LSC Responses to TIS Redline Comments

Monument Ridge East Traffic Impact Study (LSC #S234450) March 11, 2024

Add PCD File No. P245

Figure 2
Site Plan

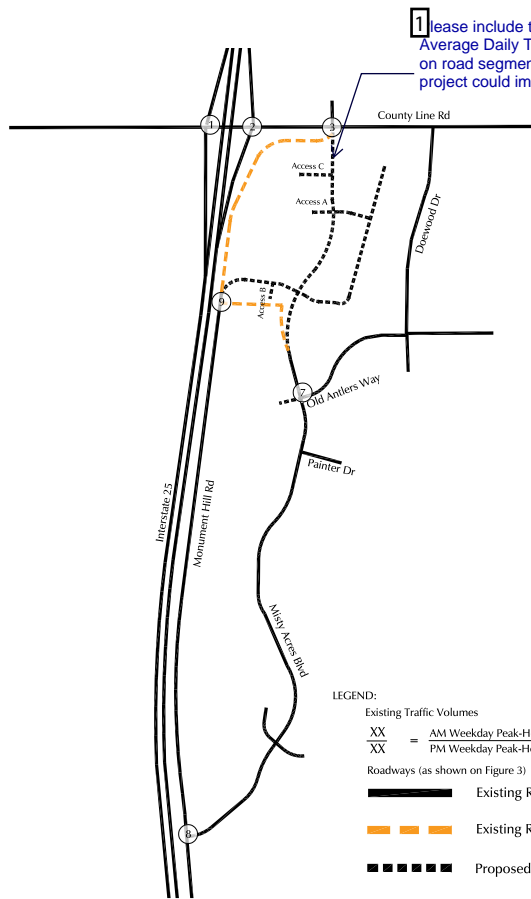
FYI: this does not meet intersection spacing per ECM table 2-7. Access location are not approved at this rezone stage and would need to be in compliance once the development plan is submitted at the subdivision stage.

FYI: this does not meet intersection spacing per ECM table 2-7. Access location are not approved at this rezone stage and would need to be in compliance once the development plan is submitted at the subdivision stage.

LSC RESPONSE: This figure has been revised. Also, a deviation has been prepared as this report is for submittal with the Preliminary Plan, too.

Figure 4
Existing Traffic Counts
Monument Ridge East (LSC # S234450)

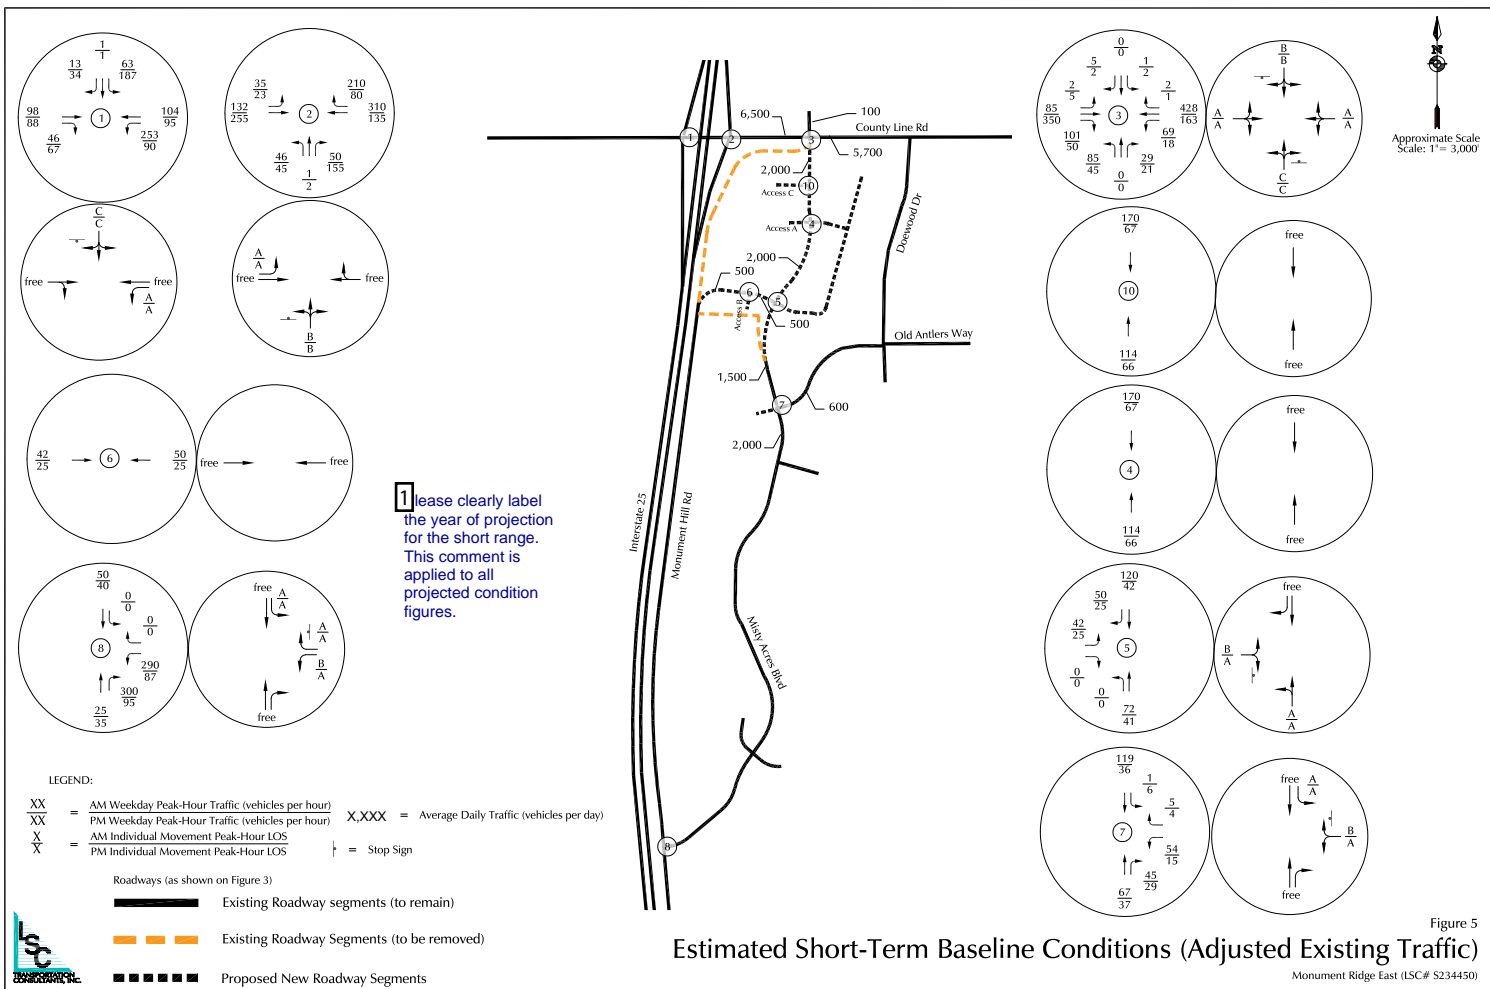
1 Please include the existing Average Daily Traffic (ADT) on road segments that the project could impact.

Please include the existing Average Daily Traffic (ADT) on road segments that the project could impact.

Author: Jack Date: 8/7/2024 5:46:31 PM
LSC RESPONSE: Revised in report, as requested

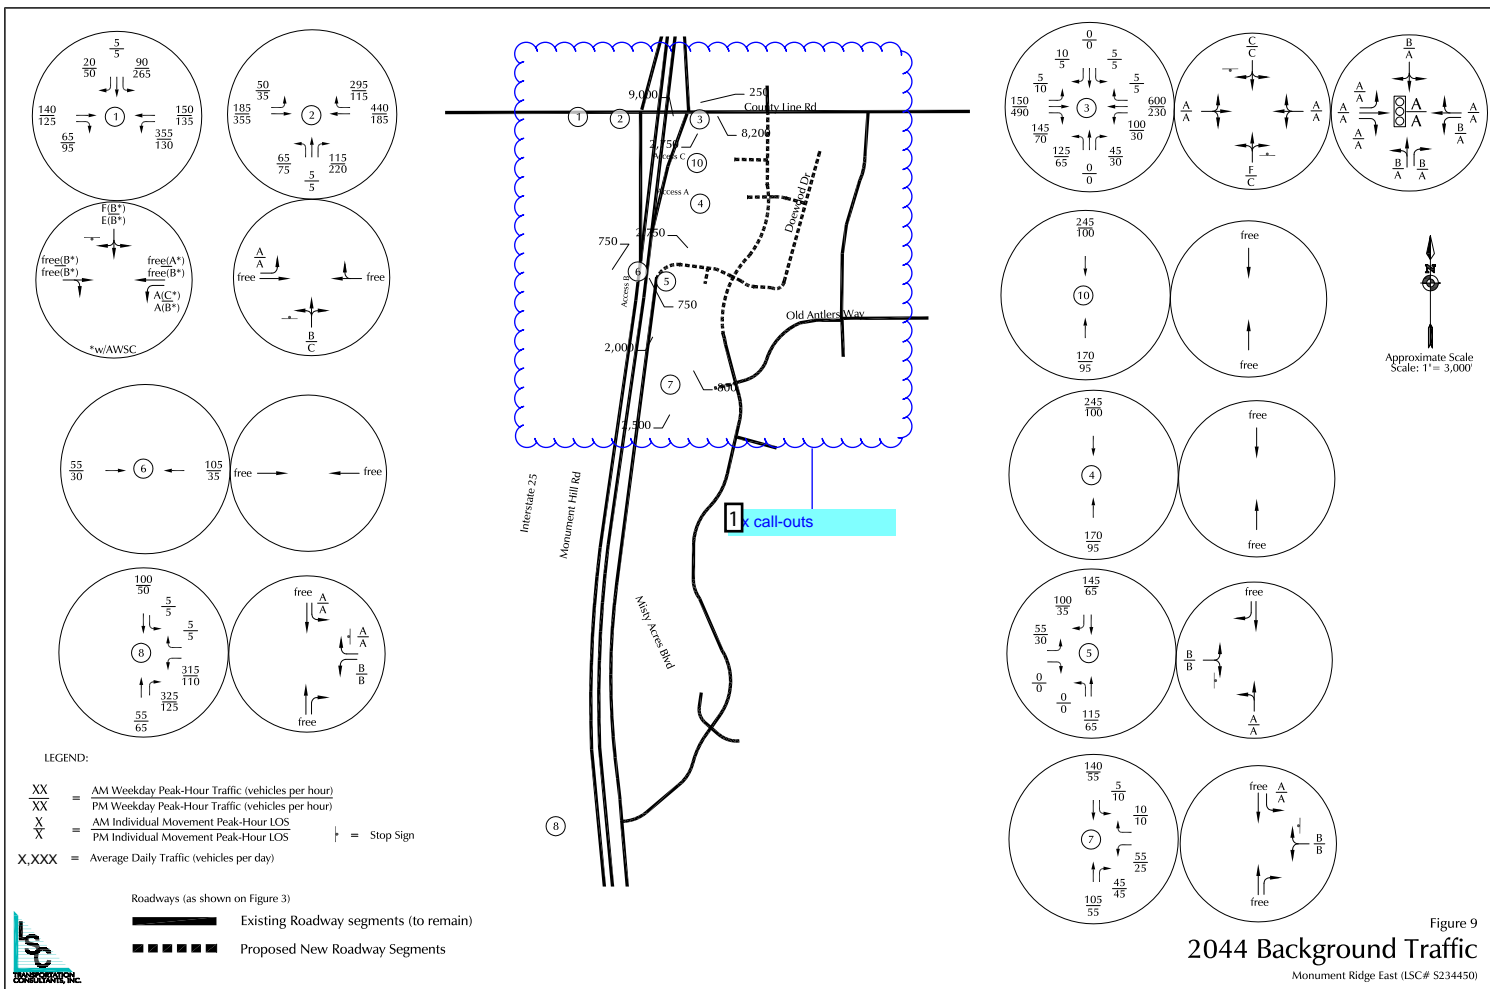
Please clearly label the year of projection for the short range. This comment is applied to all projected condition figures.

↩ Author: Jack Date: 8/7/2024 5:45:48 PM
LSC RESPONSE: Added to figure, as requested
